BB7  
3671 - Hillingdon  
Proposed Disabled Refuge Locations  
BB-DRC-3671-02  
10<sup>th</sup> January 2020  
Review by: Thomas Gibbins  
Authorised by: Dane Owen

**4 Building 11 - Roof Plan**  
1 : 200

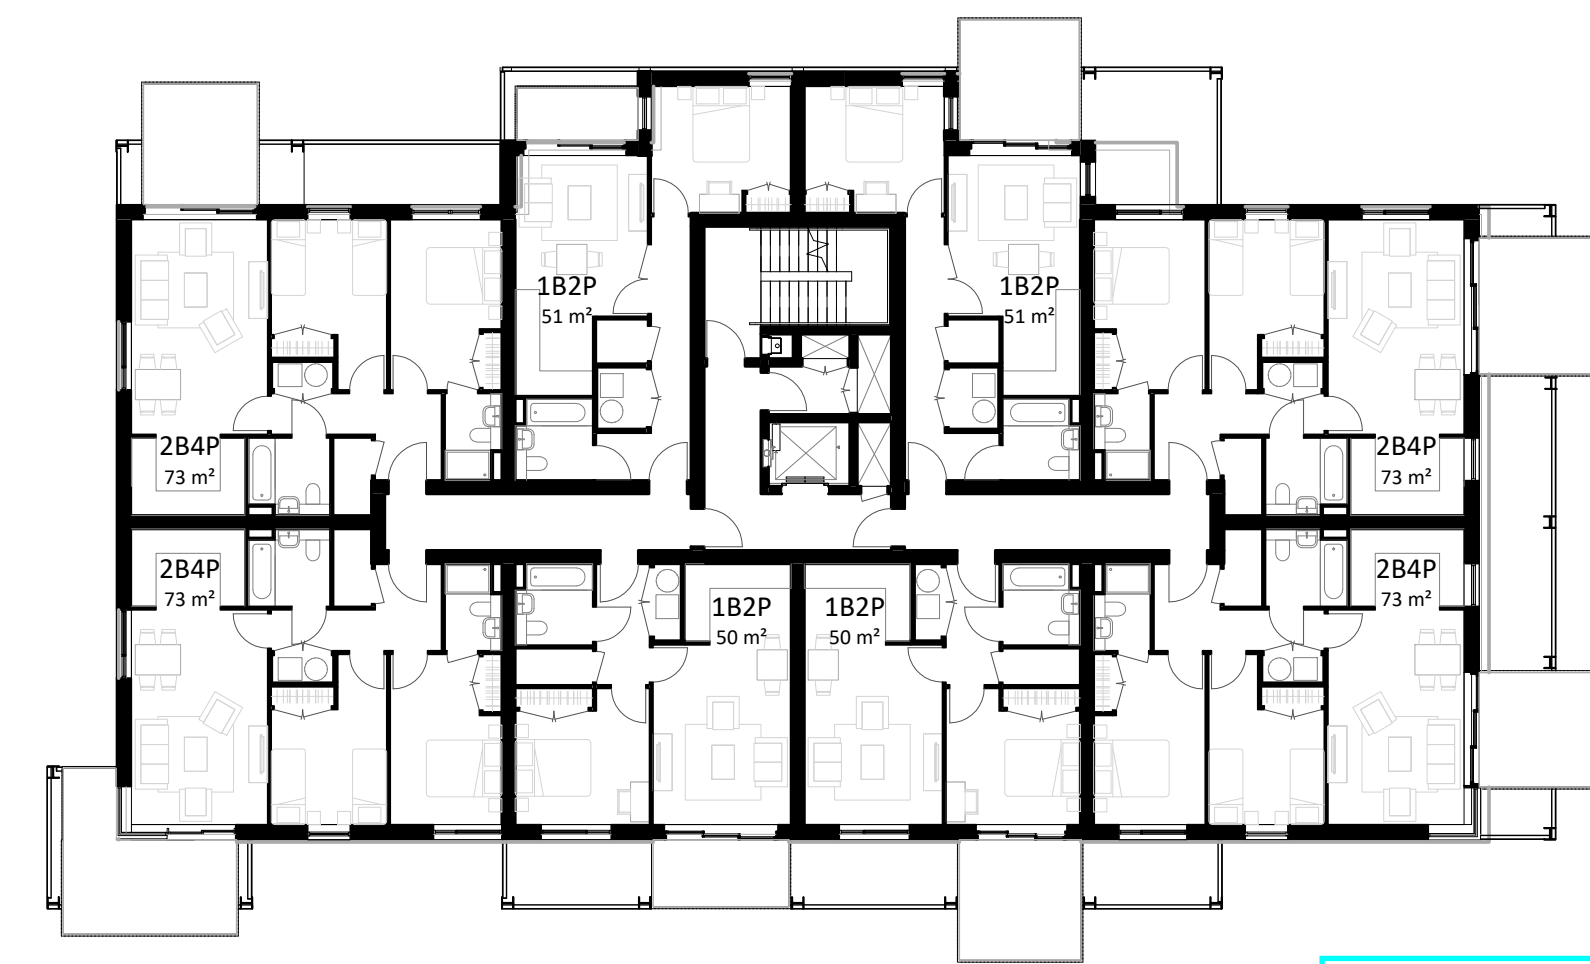
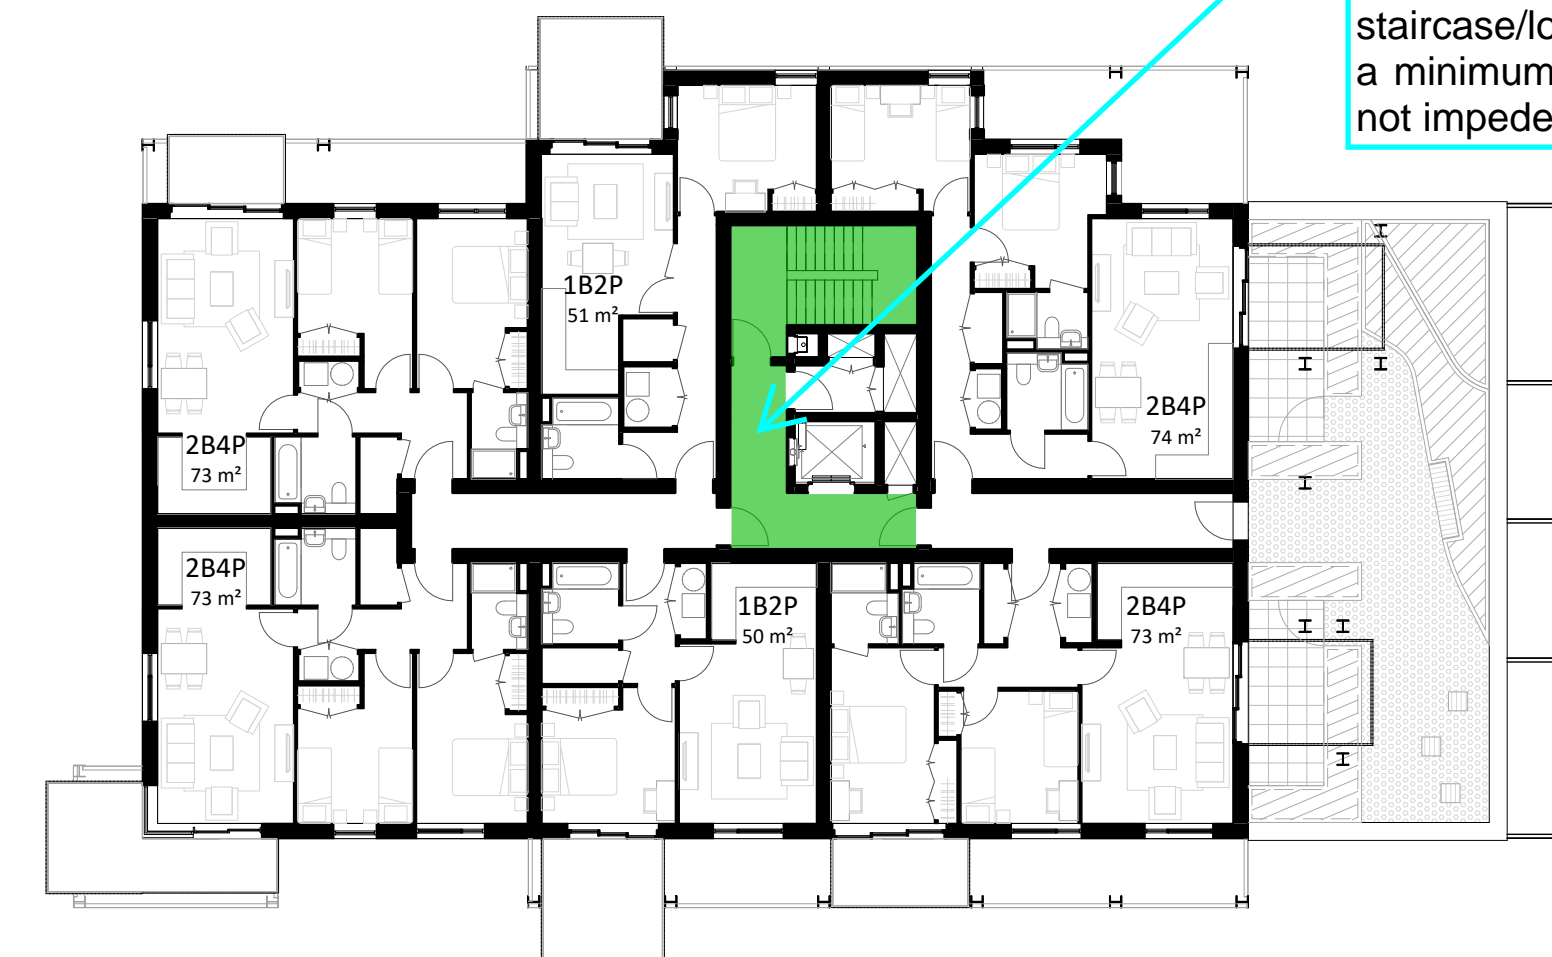
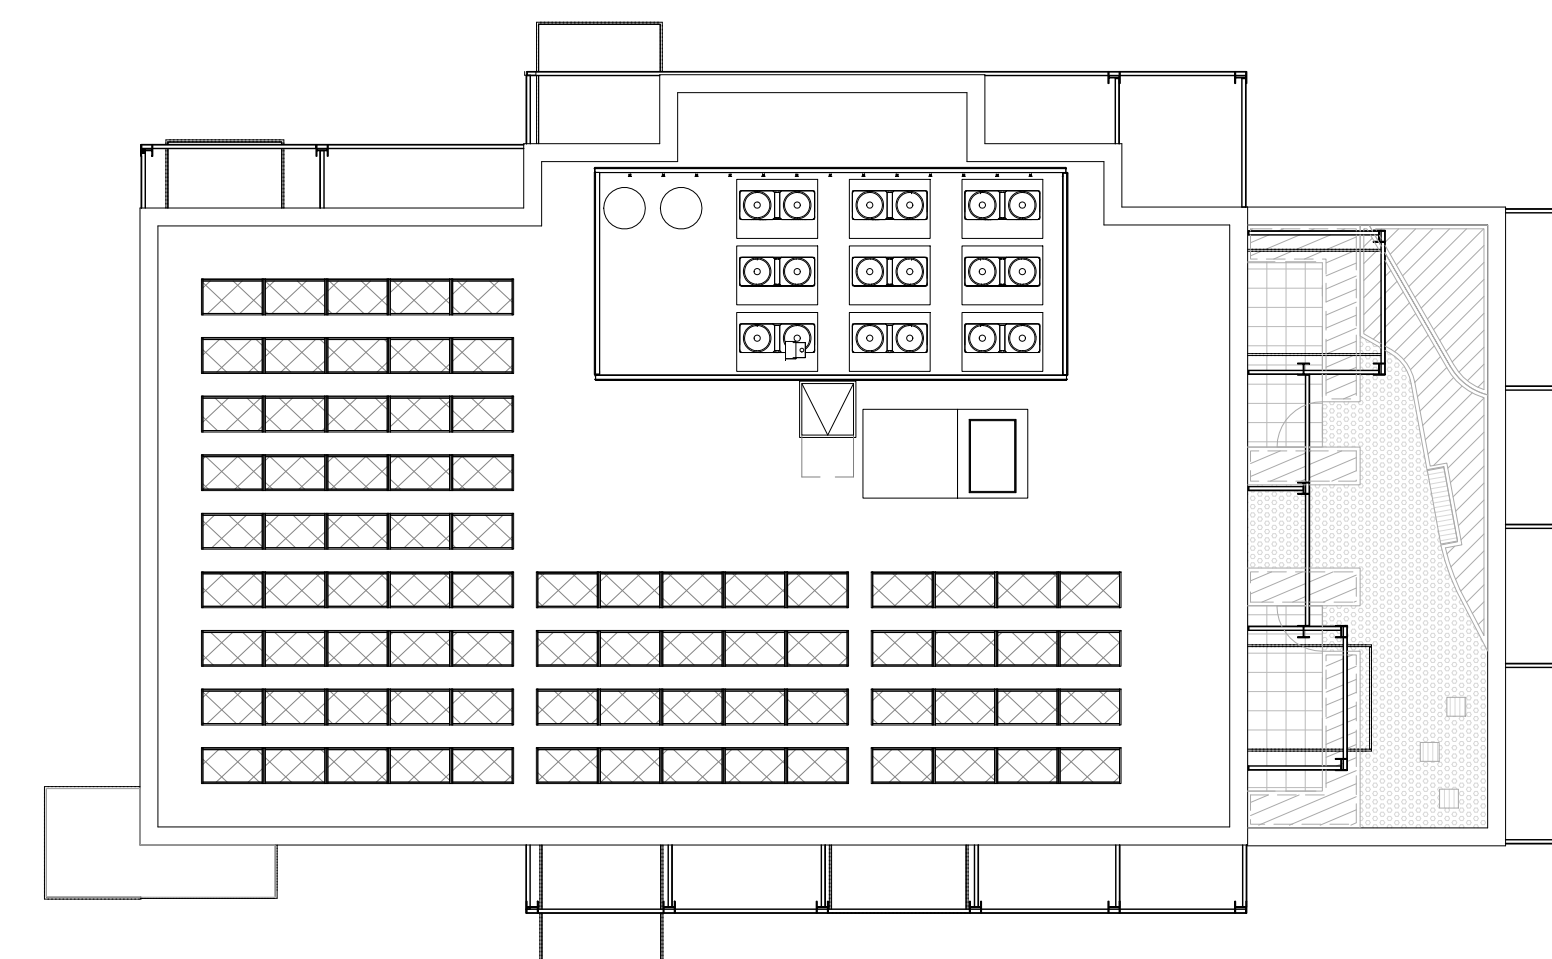
To be noted, if the roof terrace is to be used by the residents (i.e. not maintenance only), there is a risk that disabled guest may be present in a fire scenario. As such, until agreed to be omitted at the detailed design stage, it is recommended that on this level a disabled refuge is allowed for in the staircase/lobby. Disabled refuges are to be a minimum 1400mm by 900mm and are to not impede the escape route.

**4 Building 12 - Roof Plan**  
1 : 200

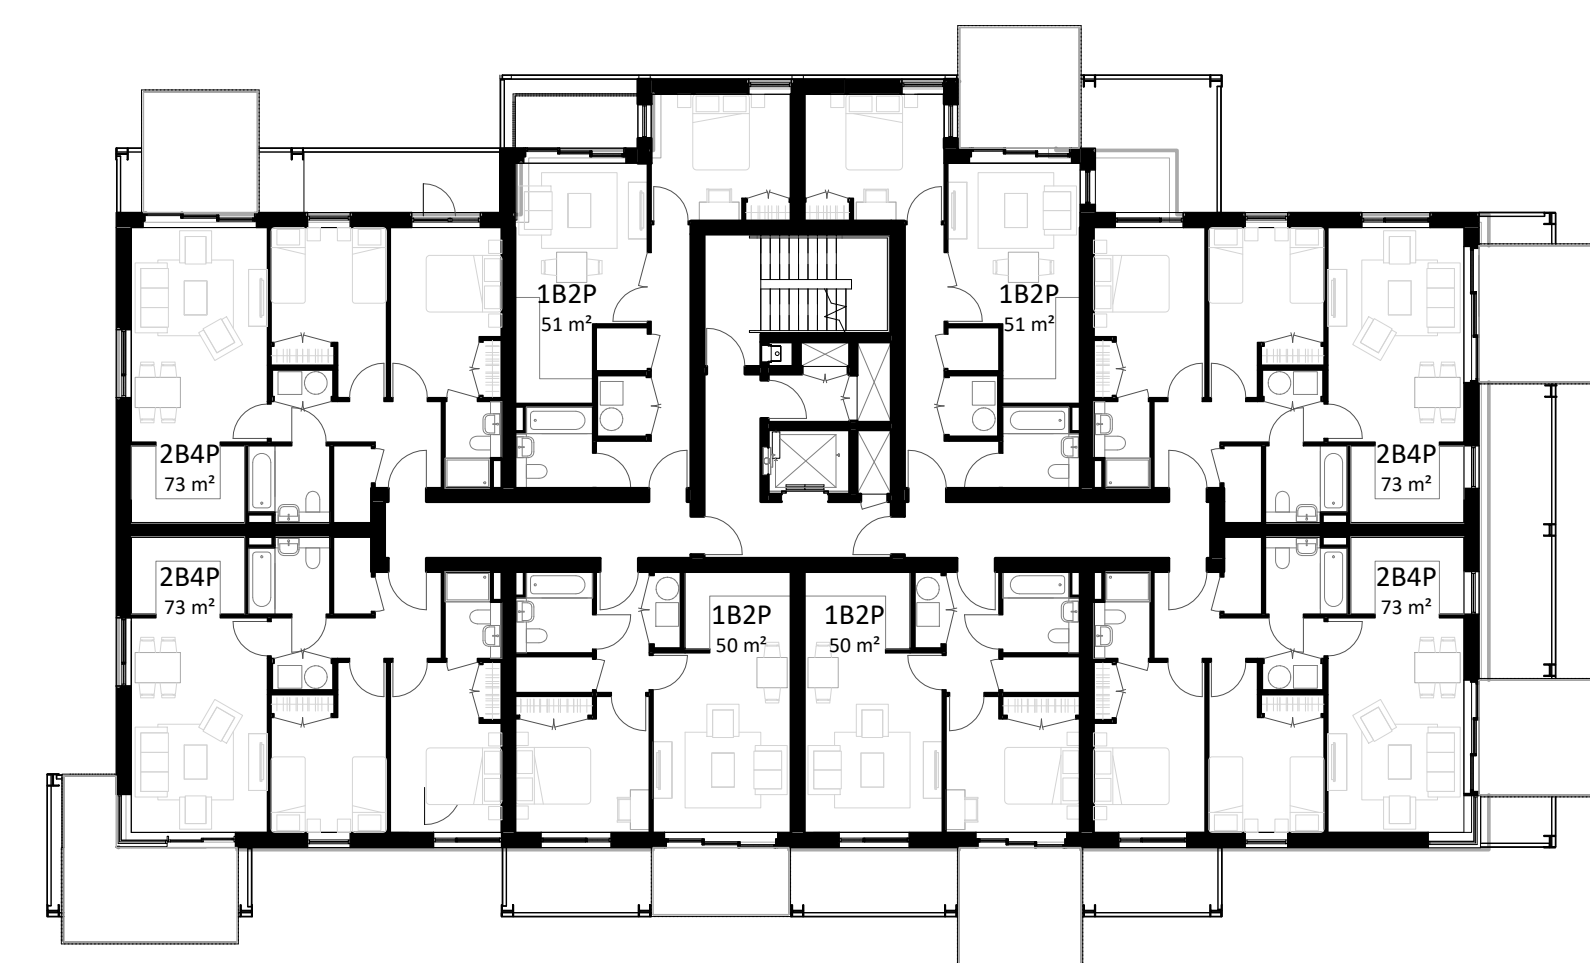
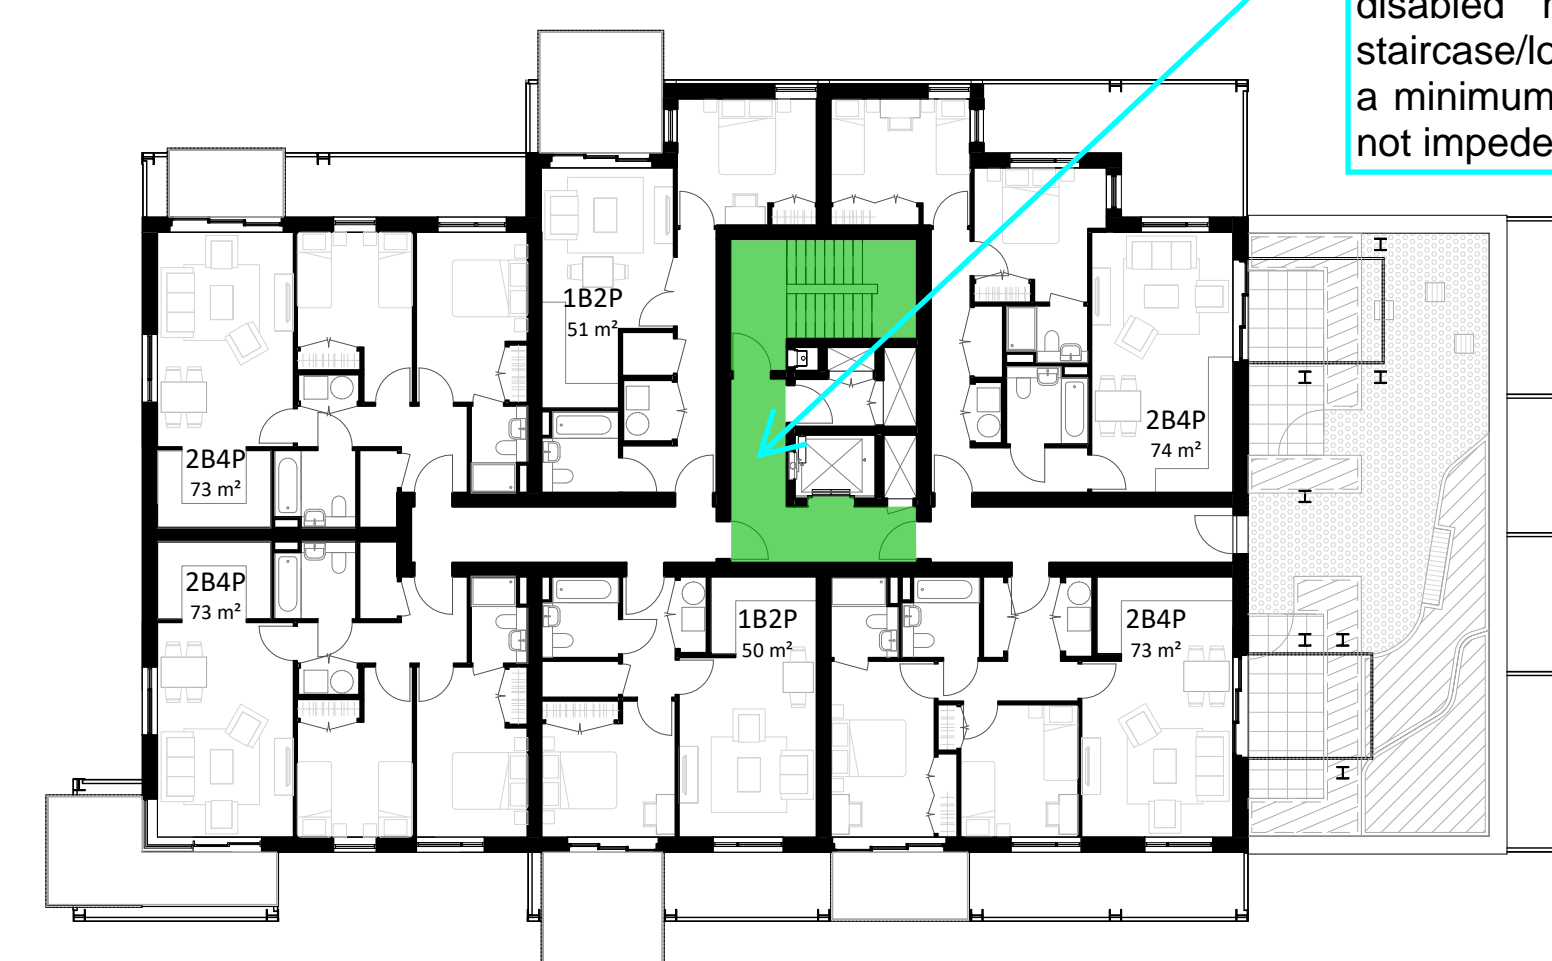
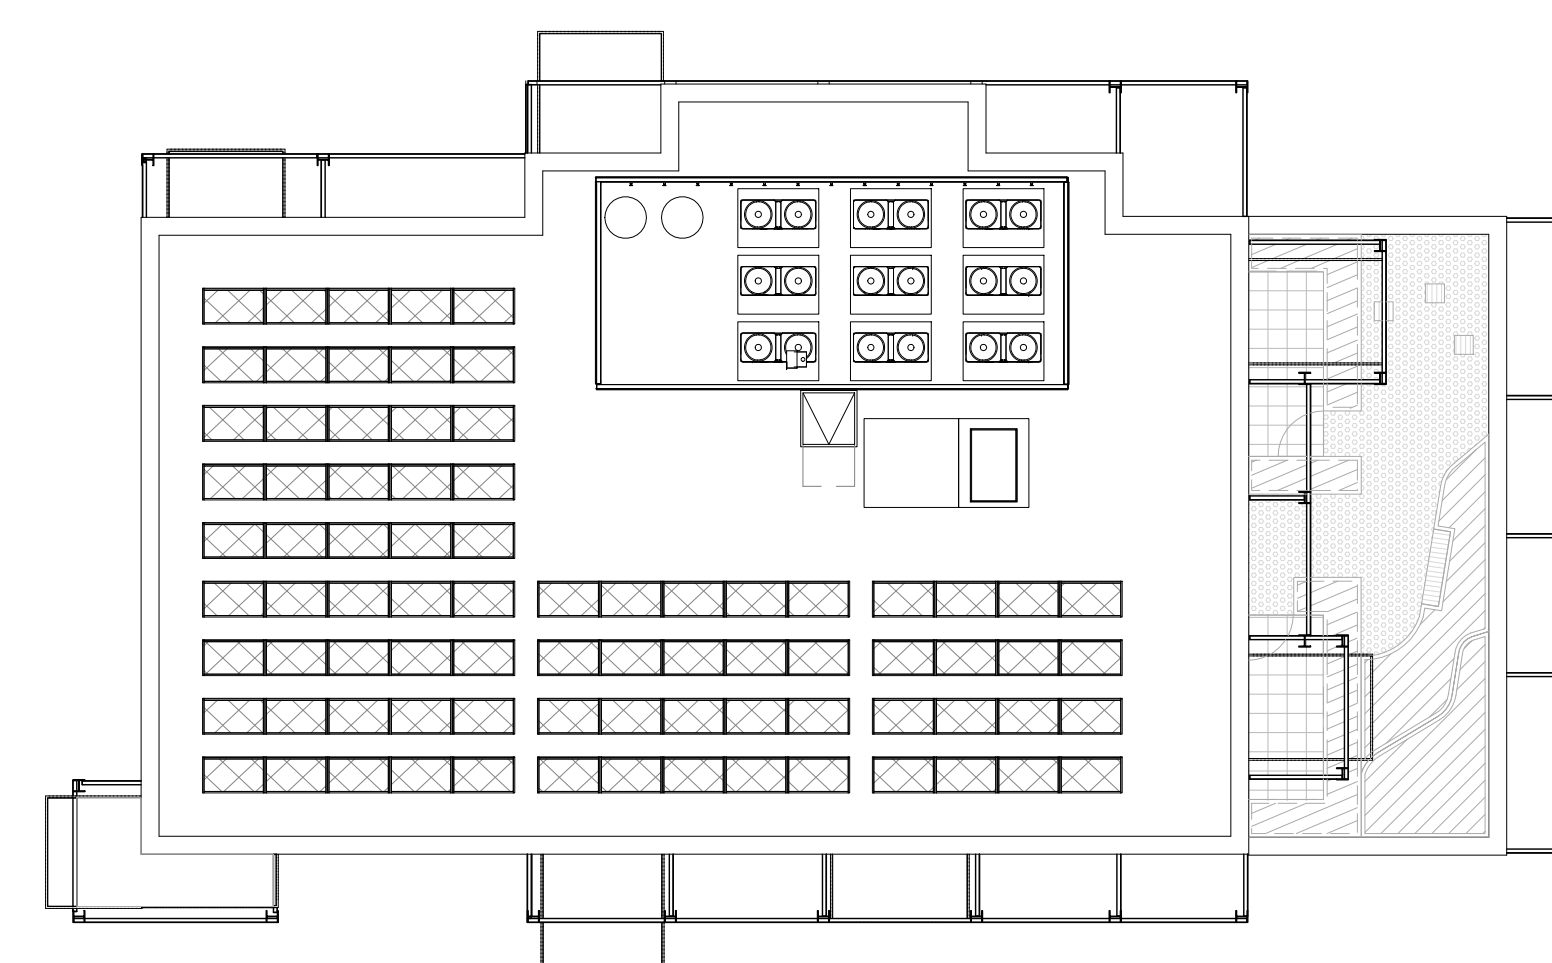
To be noted, if the roof terrace is to be used by the residents (i.e. not maintenance only), there is a risk that disabled guest may be present in a fire scenario. As such, until agreed to be omitted at the detailed design stage, it is recommended that on this level a disabled refuge is allowed for in the staircase/lobby. Disabled refuges are to be a minimum 1400mm by 900mm and are to not impede the escape route.
